Amendments to the justification part of ECE/TRANS/WP.29/GRRF/2017/12

Justification, to read:

The illustration below shows a practical example of the situation at the compensator:

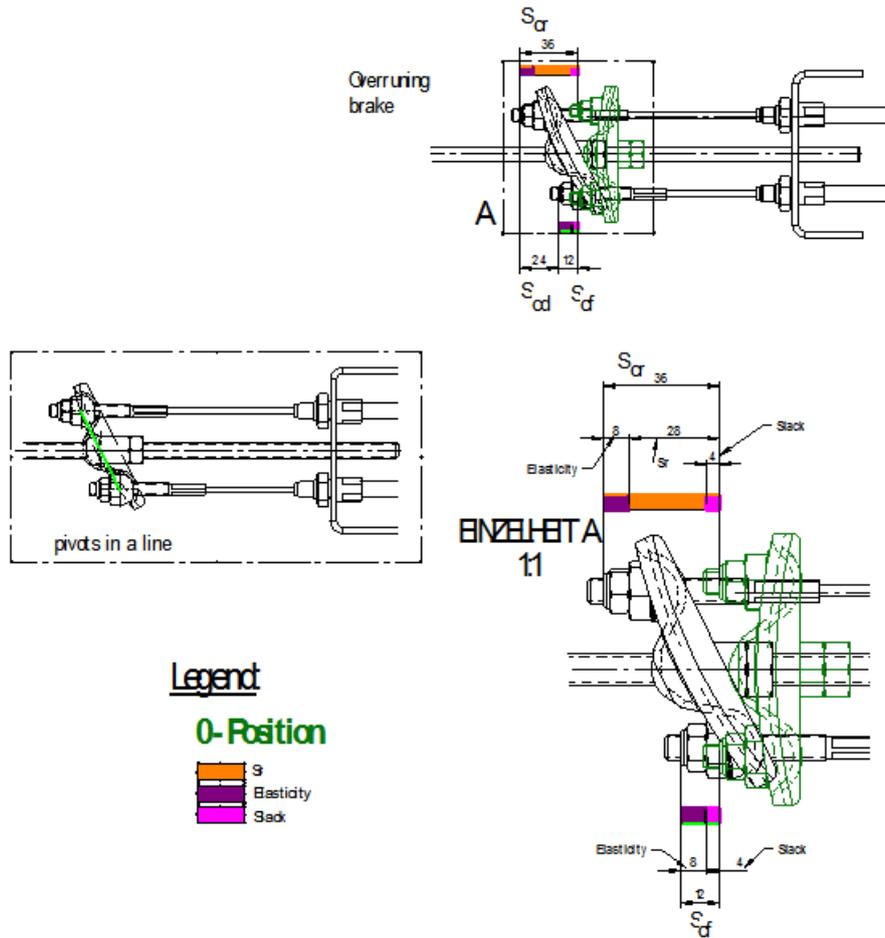
In the French proposal the minimum required compensation travel of the balancer is related to s_r , which is given in the brake laboratory test report according Annex 12, Appendix 3. So there is no need to take measurements under the trailer. On the other hand taking into account the s_B value to calculate the difference travel at the compensator in forward operation is not correct. During the tests the measurements are performed with the brake adjustment device setting so that the running clearance of the brake is close to zero. This means that the stroke at the brake lever from which a braking force is produced in forward direction is close to zero. Then, we can consider that s_r travel equals to the differential stroke at the brake between the forward direction and the rearward direction. During the life of the vehicle, the clearance of the brake will increase due to the wear of the brake linings, so that the brake lever stroke will increase both in forward and rearward direction but the difference will always be the same and equaling s_r . Thus, you can write: maximum possible differential compensator travel capacity s_{cd} must be $\geq 1,2 \cdot s_r$ which corresponds to the new proposal.

The illustration above suggests equal tension in both cables and as such equal travel due to elasticity, thus $s_{cd} \geq 1,2 (s_r - \text{slack})$. Determining the slack is extra effort, subject to measuring tolerances and assumed to be not very big. Therefore the plead is to waive it, consider it an extra safety margin and say $s_{cd} \geq 1,2 \times s_r$.
